Visual Impacts

Amber Pedersen – Burrendong SOS Representative.

Non-Compliance with EP&A Act in Use of 2024 Visual Technical Supplement

Table 6. Visibility distance zones ¹⁴

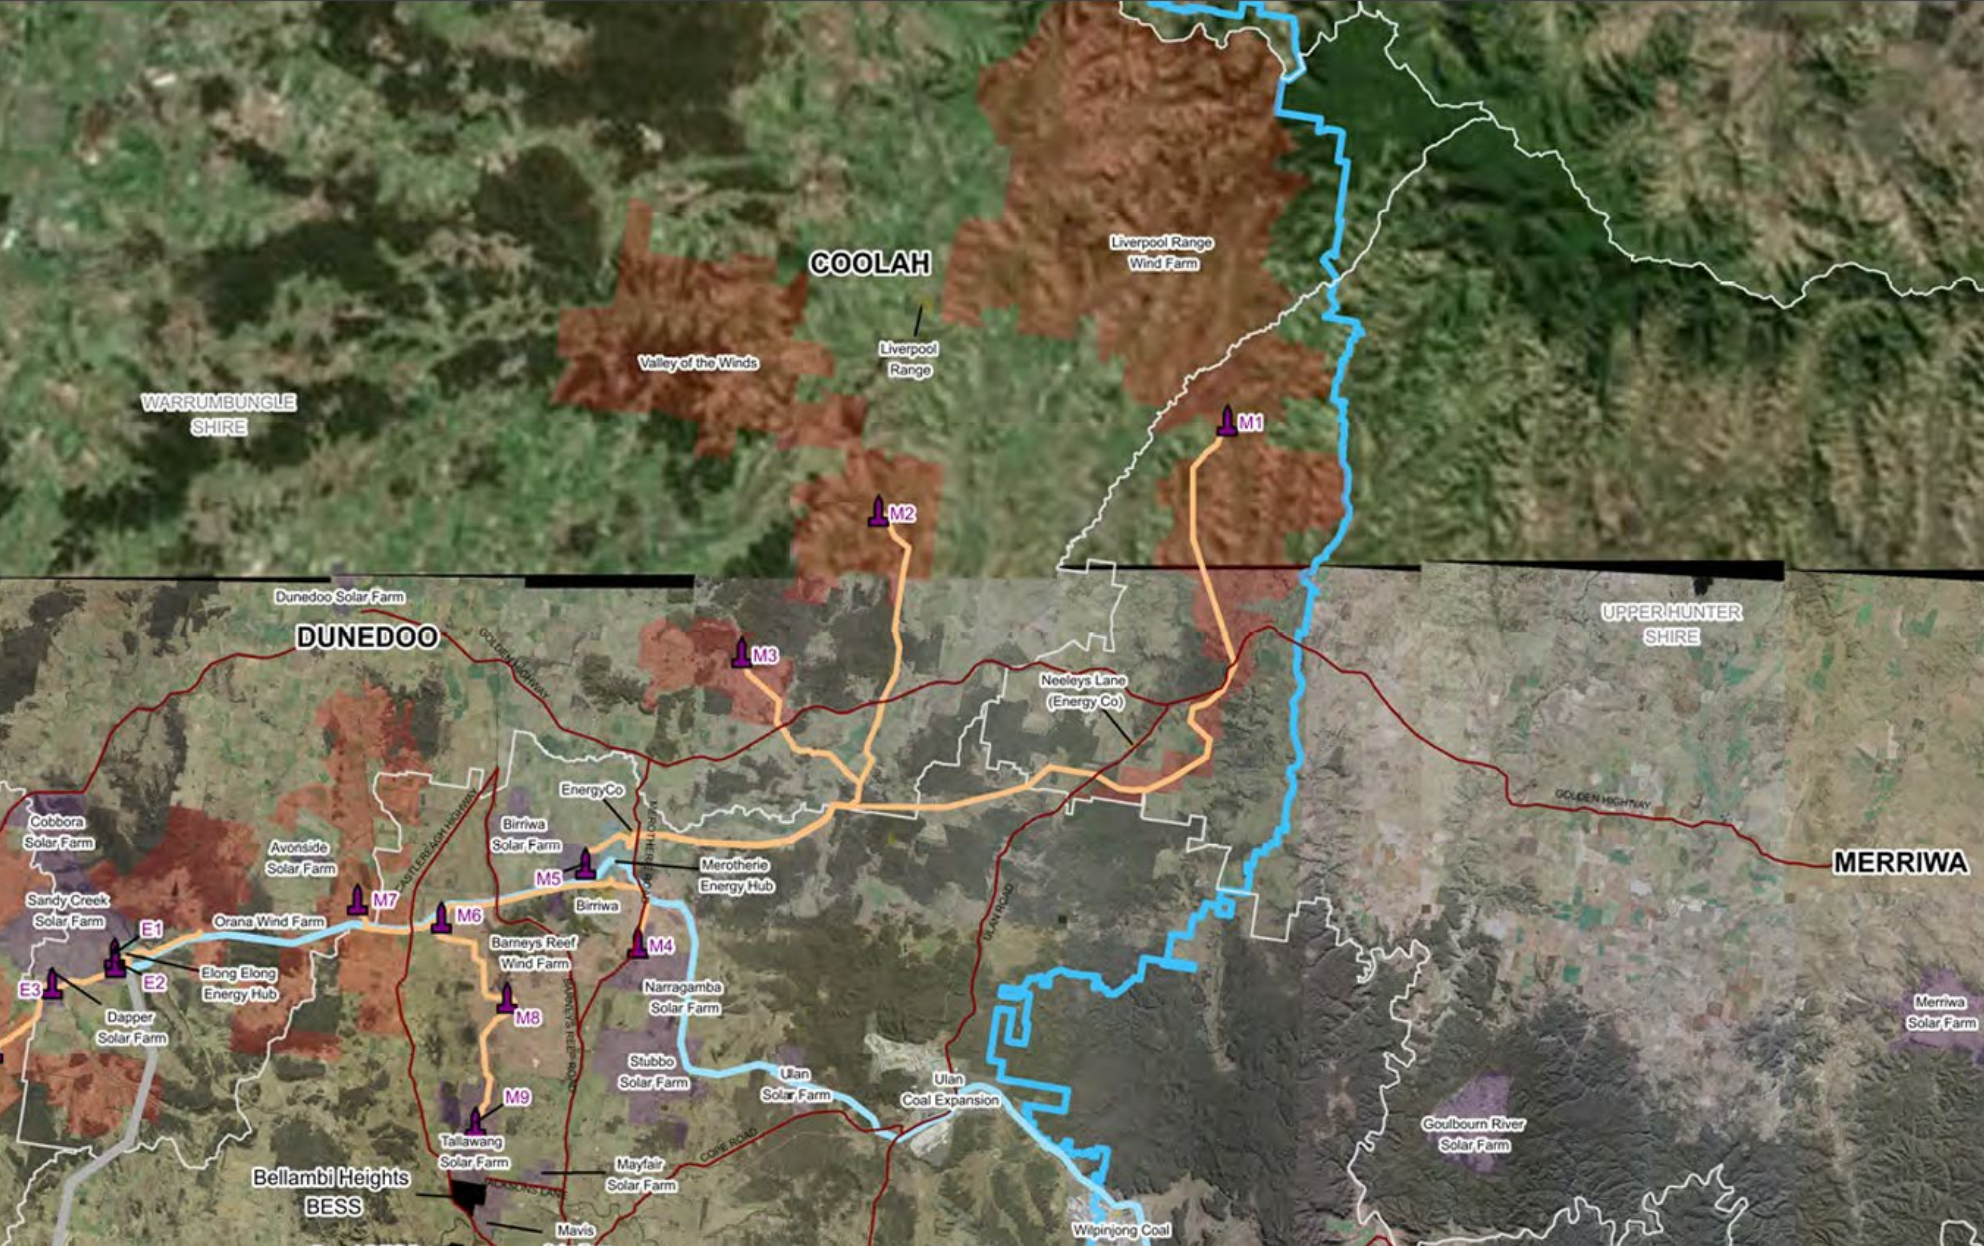
Inadequate Visual Screening provisions for Non-Associated Dwellings Beyond 4.95 km – Visual screening should be provided out to 12km

- Sullivan et al. (2012) study cited in the 2016 Visual Assessment Bulletin, found 120m high turbines under half the proposed 250m height triggered maximum visual impact ratings at a distance of 6.4km and up to 9.7 km away.
- VAB Table 2 states: “the blue (3.35km) and black line (4.95km) in Figure 5 are not determinative of acceptability. Instead they provided a basis for the assessment to be undertaken”.
- Table 6 of the 2016 VAB confirms visual magnitude and influence impact can extend beyond 32 km.
- Cumulative visual impacts on landowners, forced to live within ‘a modern day power station’ – CWO REZ without their consultation or consent must be fairly ameliorated.

Figure 12 Preliminary Assessment Tool 2: Multiple Wind Turbine (Map Source: Six Maps)

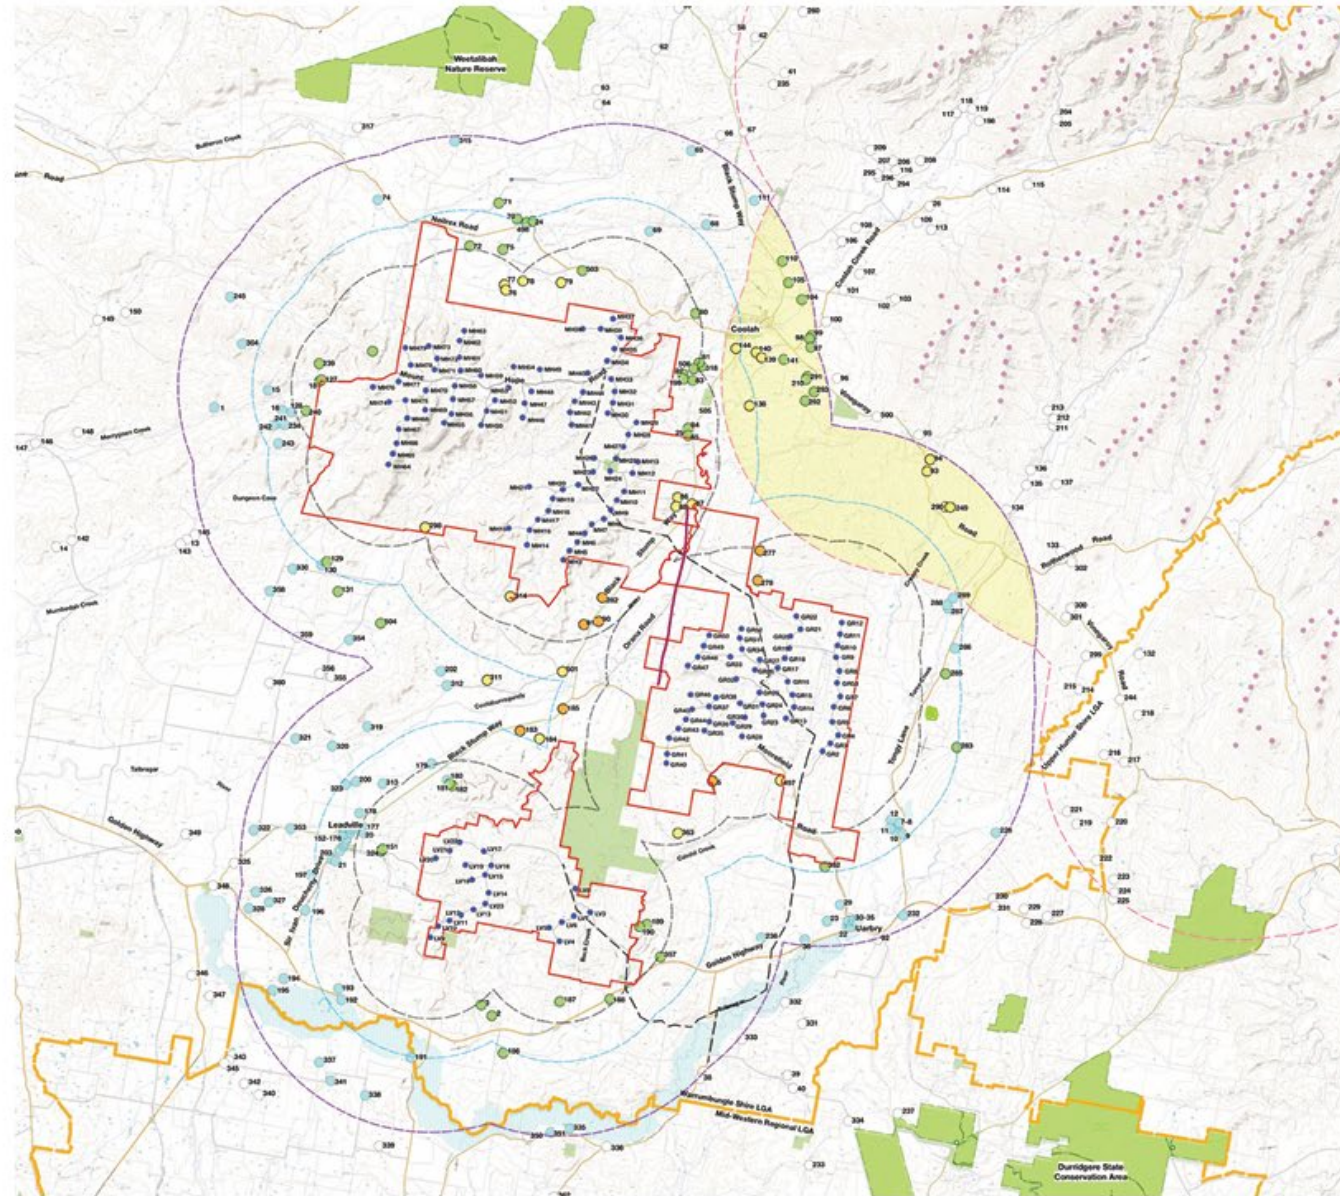
Cumulative visual impacts on landowners

- Coolah township is 5km and 4km from the TWO projects (total of 316 turbines) surrounding it - TILT's Liverpool Range 185 x 215m turbines to the NE of town and ACEN's Valley of the Winds 131 x 250m turbines to the E, SE, S, SW of town.

- Whilst the department says there are 8 projects within 20km of the site “consistent with the location of the project within a REZ” , it has to be noted that cumulative impact to residents cannot be ignored just because the government draws a line around their homes without consultation nor consent and said you now live in a “modern day power station” (as aptly described by EnergyCo).

- Cumulative effects should still be considered for each resident out to 12km of the project and if anything they should be afforded **increased** visual mitigation measures, given their residences and properties will be surrounded by 316 turbines compared to someone who lives outside of the REZ. This would be a far more appropriate mitigation measure than any funding received from a ‘Voluntary Planning Agreement’
